**Exhibit F: UCSC-Addendum to CLRDP submitted 3/28/06**

March 28, 2006  
University of California Marine Science Campus  
Coastal Long Range Development Plan

Addendum to the CLRDP  
as submitted to the California Coastal Commission  
on January 25, 2006

**Exhibit G: Figure Changes**

Fig. 5.4 Development Subareas (10)

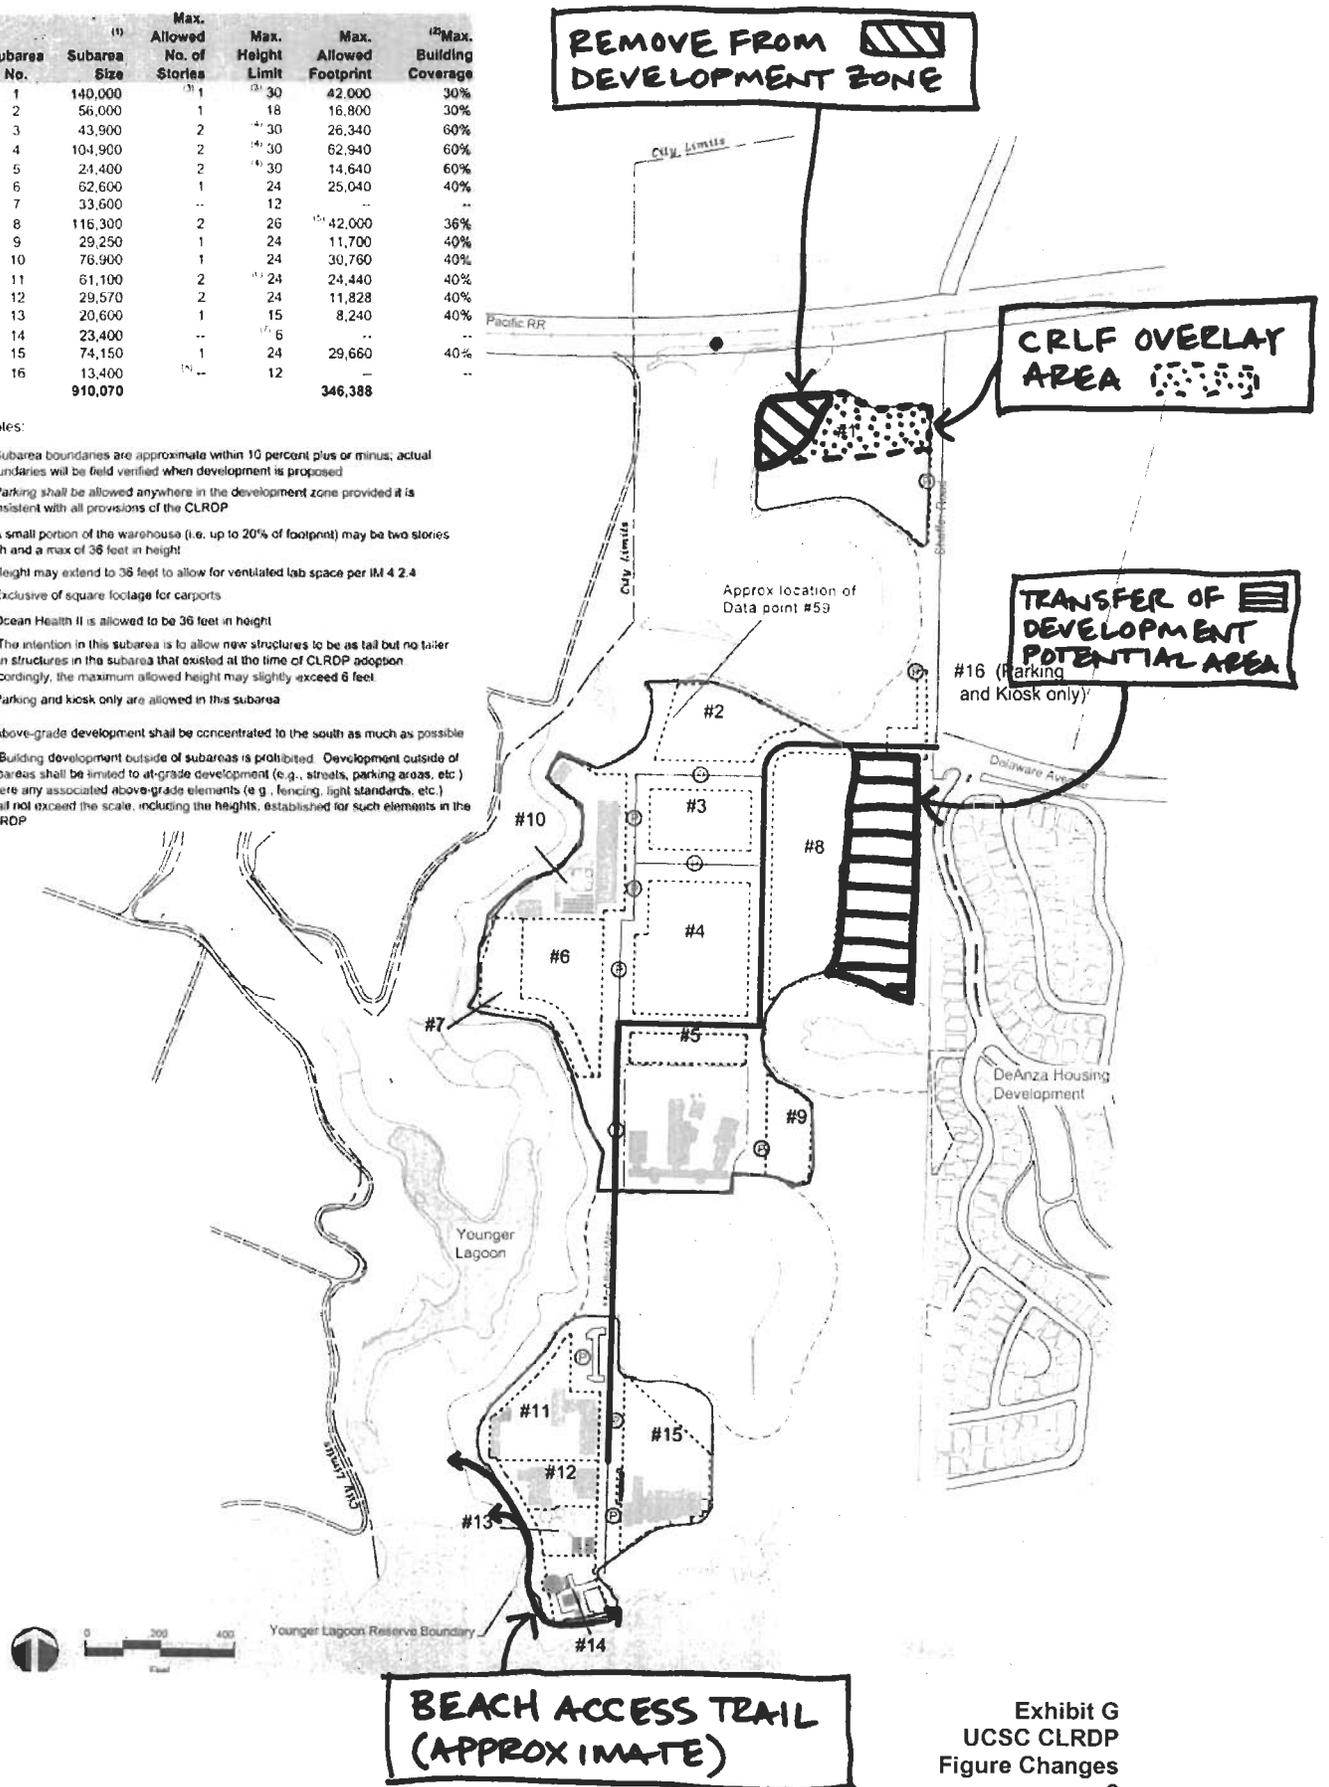
5. For Figure 5.4:
  - a. Make adjustments as necessary to be consistent with Figure 5.2.
  - b. Add explanatory language for Figure 5.4 at the end of paragraph 5.4.1 stating that this figure identifies maximum scale and related criteria for buildings and other development in various subareas of the development zones.

- c. Add new Implementation Measure 4.2.15 as follows:  
Implementation Measures 4.2.15. Development Outside of Identified Subareas. Building development outside of the subareas shown in Figure 5.4 is prohibited. Development outside of the subareas shown in Figure 5.4 and inside of development zones shall be limited to at-grade development (e.g., streets, parking areas, etc.), where any associated above-grade elements (e.g., fencing, light standards, etc.) shall ~~be~~ not exceed the scale, including the heights, established for such elements in the CLRDP.

- d. Delete the reference to Implementation Measure 3.4.4 relative to the Upper Terrace zone.
  - e. Change labels as follows: "Allowed No. of Stories" to become "Maximum Allowed Number of Stories," "Height Limit" to become "Maximum Height," "Allowed Footprint" to become "Maximum Building Footprint," "Building Coverage" to become "Maximum Building Coverage"

- f. Delete subarea 17.
  - g. Add footnote number 9 and apply that footnote to subarea 2; footnote 9 to state as follows: "Above-grade development shall be concentrated to the south as much as possible."

- h. Add footnote number 10; apply that footnote to subareas 7 and 14, and 16; footnote 10 to state as follows: "Buildings prohibited in this subarea, except that an entryway kiosk is allowed in subarea 16." Replace the "1" noted in the number of stories columns for subareas 7 and 14 with a "--" reference instead.

- i. Expand subarea #16 to the south to include the entry road (extension of Delaware Avenue) and revise the annotation to read: "Parking and kiosk only."

- j. Add global footnote to apply to whole figure that states: "Building development outside of subareas is prohibited. Development outside of subareas shall be limited to at-grade development (e.g., streets, parking areas, etc.) and associated above-grade elements (e.g., fencing, light standards, etc.), which shall not exceed the scale, including the heights, established for such elements in the CLRDP."

- k. Change the "7" noted under the height limit column for subarea 14 to a "6."
- l. Delete the footnote reference to footnote 6 for subarea 16.
6. Update all figures consistent with revised Figures 5.2 and 5.4.

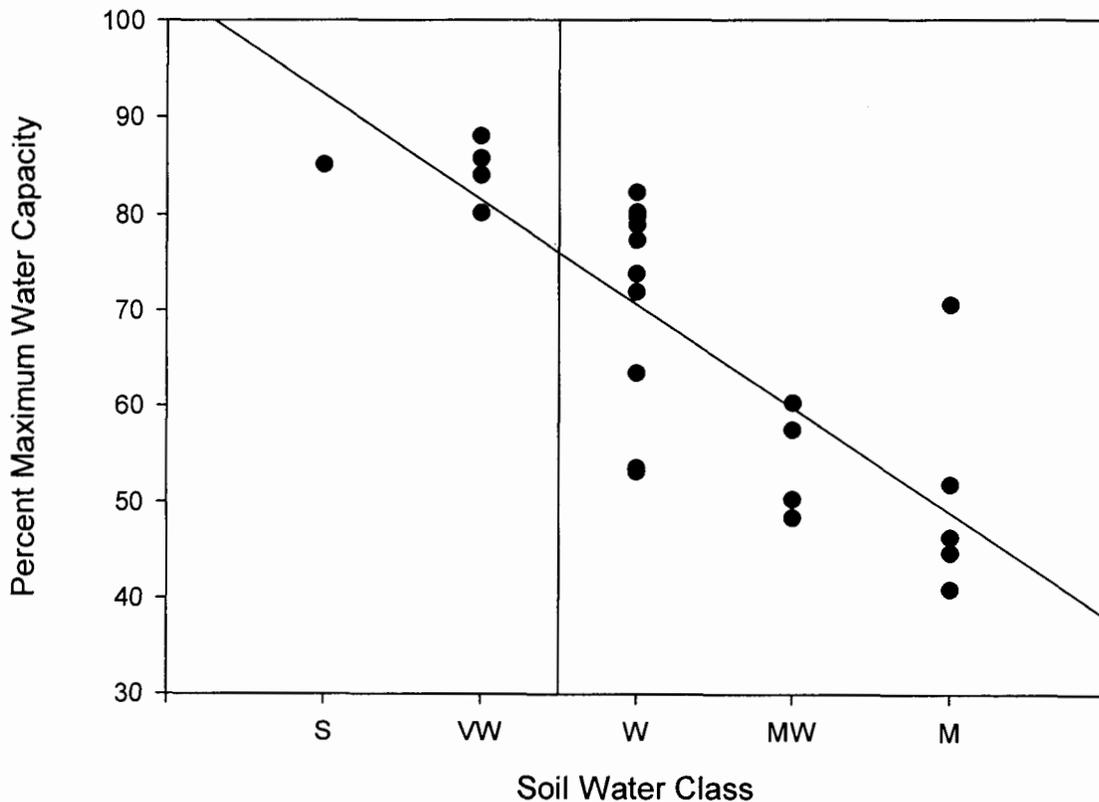
On the other hand, some of the data analysis was not conservative in the direction of resource protection. Because rainfall was unusually high during both December 2001 and December 2002, Huffman elected to ignore data collected prior to January 30, 2002 and did not begin to collect data in 2003 until January 31 in an effort to assess "normal" conditions. The affects of this decision during Phase III (2002-2003 rain season) cannot be assessed. However, data were taken but not analyzed during the previous year (Phase II). Nine data points were potentially affected (points 1, 2, 4, 5, 6, 9, 15, 40, 55) since there was evidence of soil saturation on one or more survey dates prior to the end of January. Nearly all of these locations were very near a delineated wetland boundary and would be contained within the buffer zone. Only one point (15) was in an area

likely to be affected by development (the proposed maintenance area), but it was dominated by rye grass and did not have more than 50% wetland indicator plants, suggesting upland conditions. I conclude that the decision not to analyze the earlier data probably had little practical affect on the on the ultimate determination of wetland locations and boundaries.

There was one location (data point 59) in the northwest portion of the field south of Delaware where the data were ambiguous and Huffman did not delineate a wetland. I initially agreed, but upon further reflection decided that in the face of significant uncertainty the area should be delineated. With this addition, I believe that the 2004 wetland delineation is accurate and conservative.
